UNITED STATES PATENT AND TRADEMARK OFFICE

Office Action Summary	Application No. 10/605,234	Applicant(s) CHANG ET AL.	
	Examiner Khiem D. Nguyen	Art Unit 2823

DETAILED ACTION

AMENDMENTS TO DRAWING FIGURES

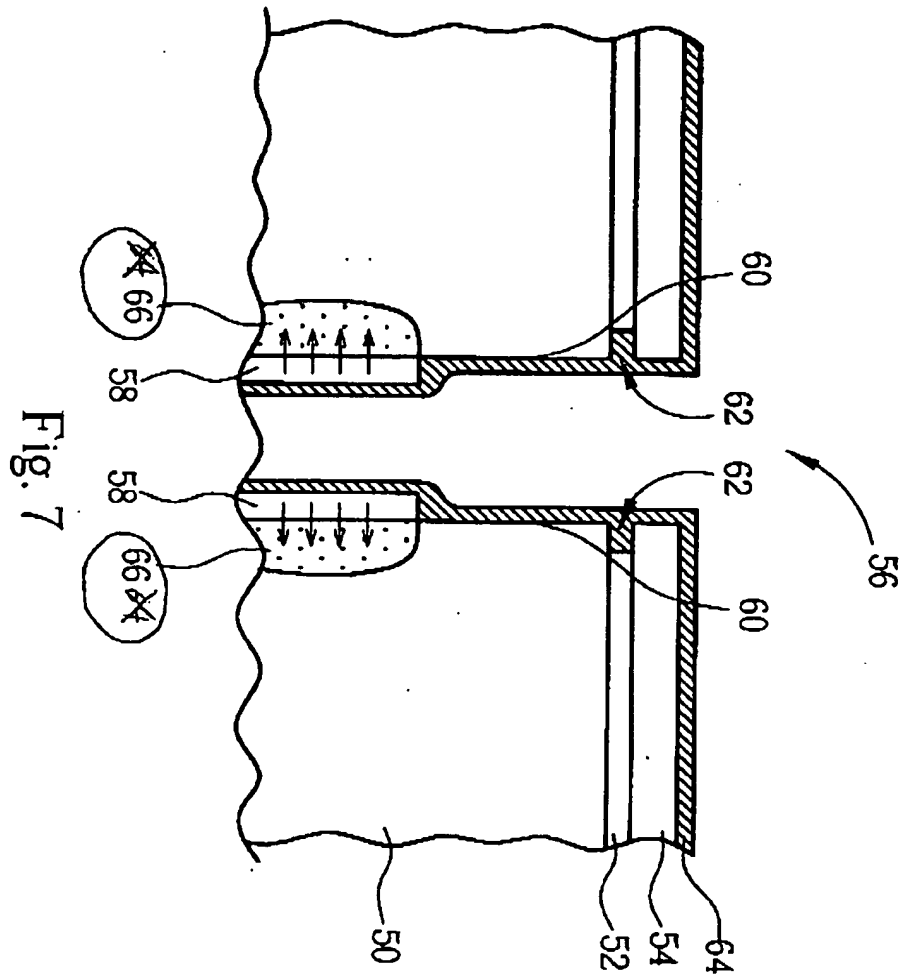
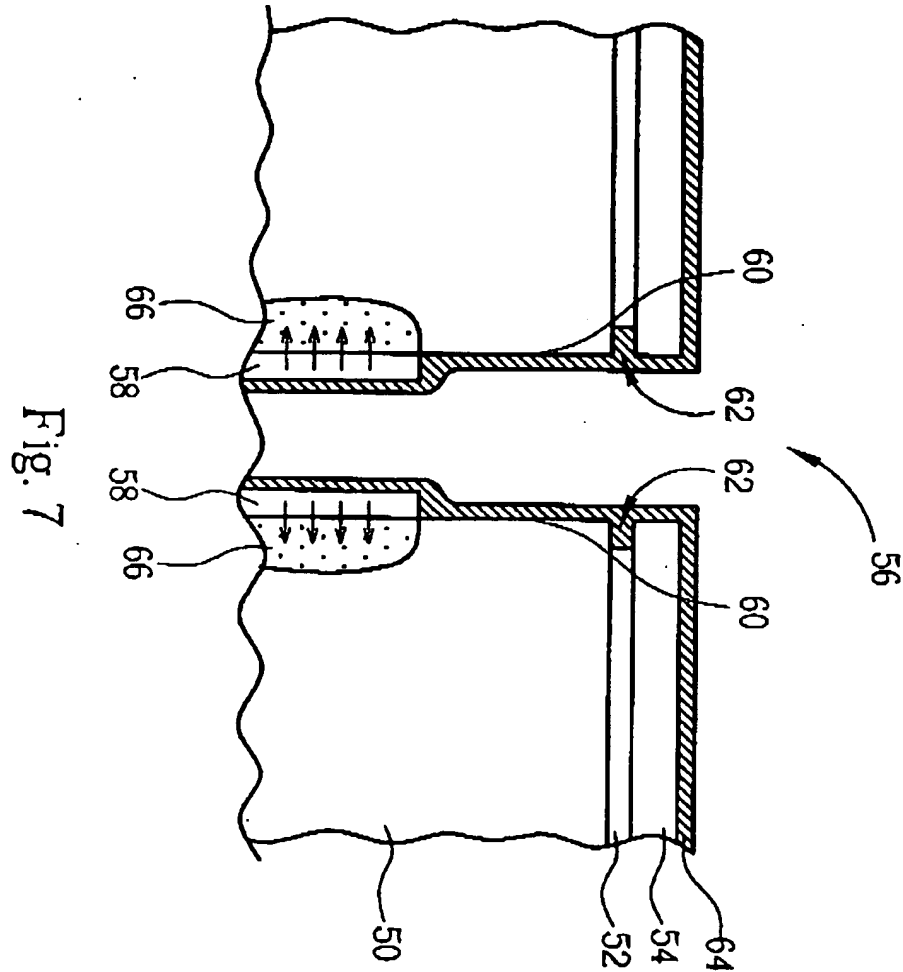
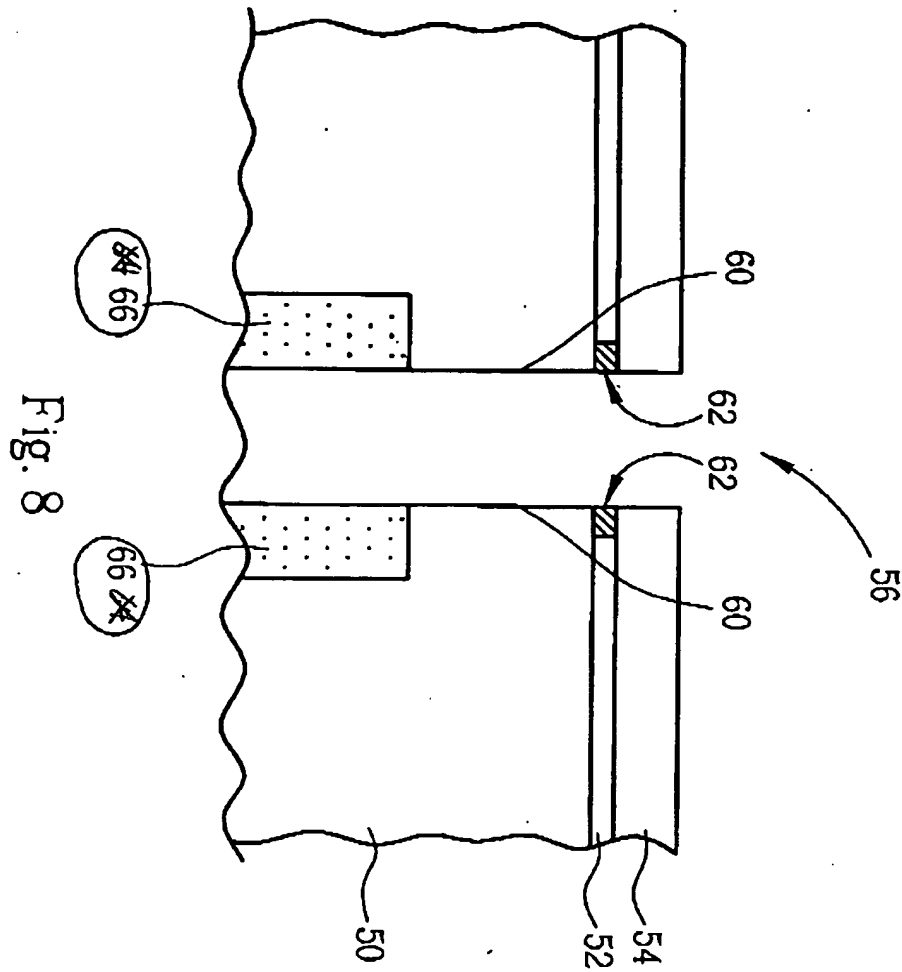
Figs.7 and 8 have been redrawn to change the numerals "64" of the doped region to "66" as shown in the encircled area of the attached "Annotated sheet". The applicant had mistakenly used the numeral "64" to refer to two different elements, and this error has been corrected. No new matter is introduced by the above amendments. Consideration of the proposed amendment to the drawings is politely requested.

Approved
